From: [REDACTED]
Sent: 25/11/2023 6:03:39 PM
To: Council Northernbeaches Mailbox
Cc: [REDACTED]
Subject: Submission for application Mod2023/0554
Attachments: Objection to Boat Ramp to 316 Hudson Pde Clareville10046_Kim edit and removed 2 appendix.pdf;

Please find attached our submission for Mod2023/0554 for the modification of development consent DA2020/1762 granted for demolition works and construction of boatshed, ramp, slipway, jetty and steps.

In relation to the Modification of Development Consent DA2020/1762, granted for demolition works and construction of boatshed, ramp, slipway, jetty and steps (application number Mod2023/0554).

Image A: Google Earth screen shot approx. 2016

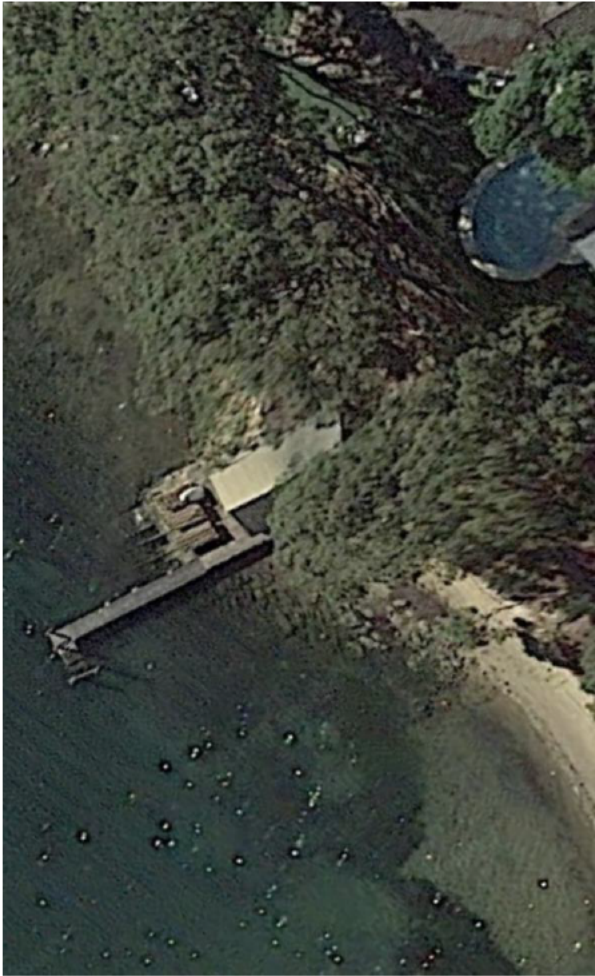
Image A shows the original boat house with jetty and jetty pylons.

Image B: Aerial photo 2nd November 2018

The more recent Image B shows the footprint of the new boat house.

Image C: Overlay of Image A and Image

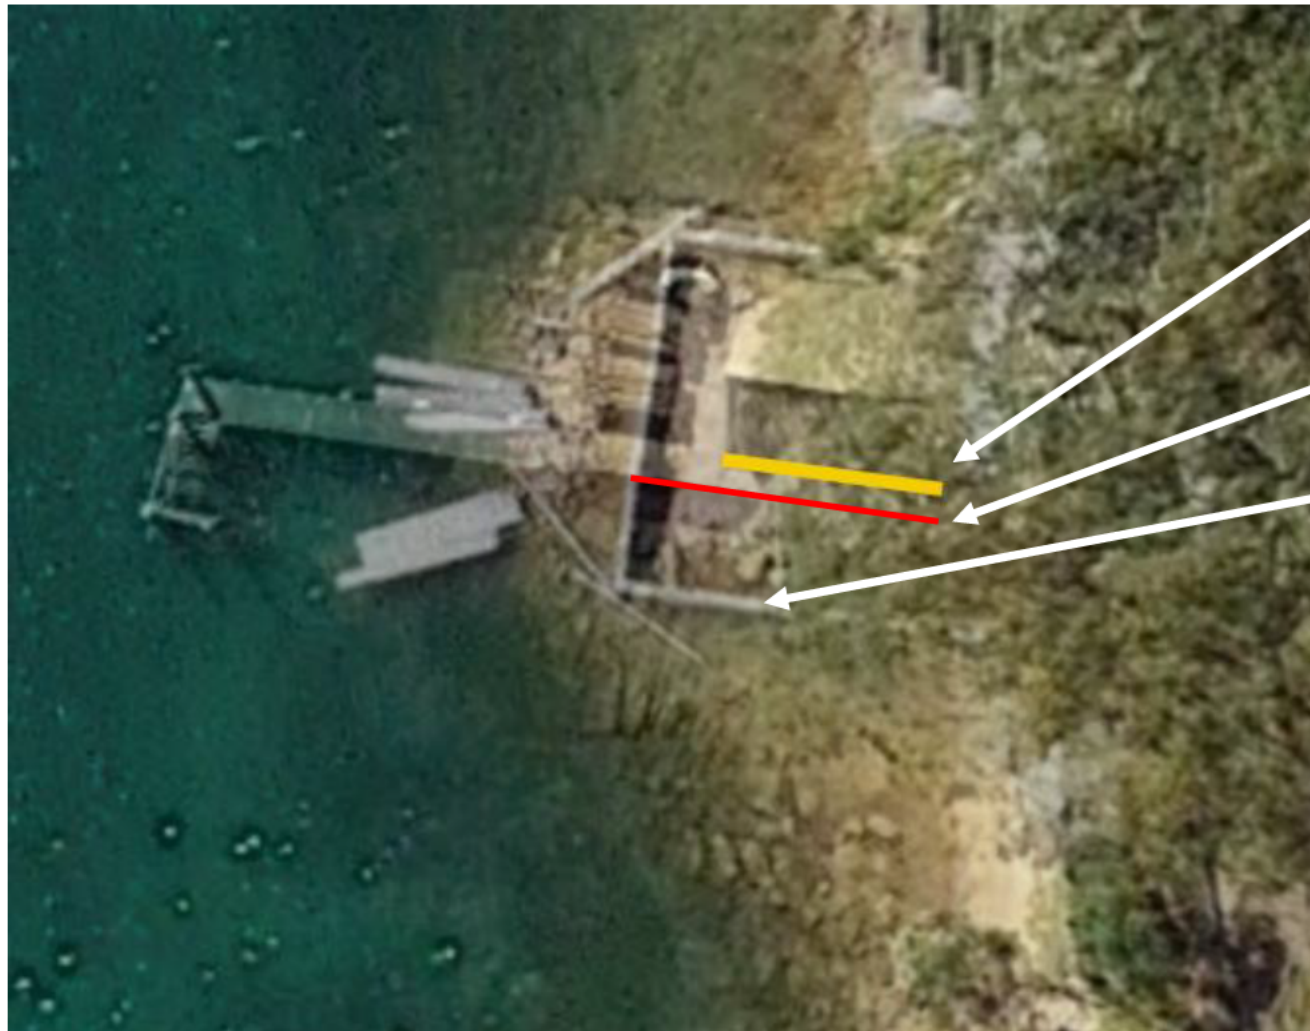
Approx. location of original sandstone wall of previous boat house.

Approx. Location of the original sandstone wall

Location of new southern Dintel wall, considerably further south than the original sandstone wall footprint

These images show the southern Dintel wall of the new boat house is significantly further south than the sandstone wall of the original boat house.

Image C is an overlay of Image A & B, in which you can see the new southern Dintel wall is now in line with the southern two jetty pylons, whereas the southern wall of the previous structure was set back and to the north from these pylons
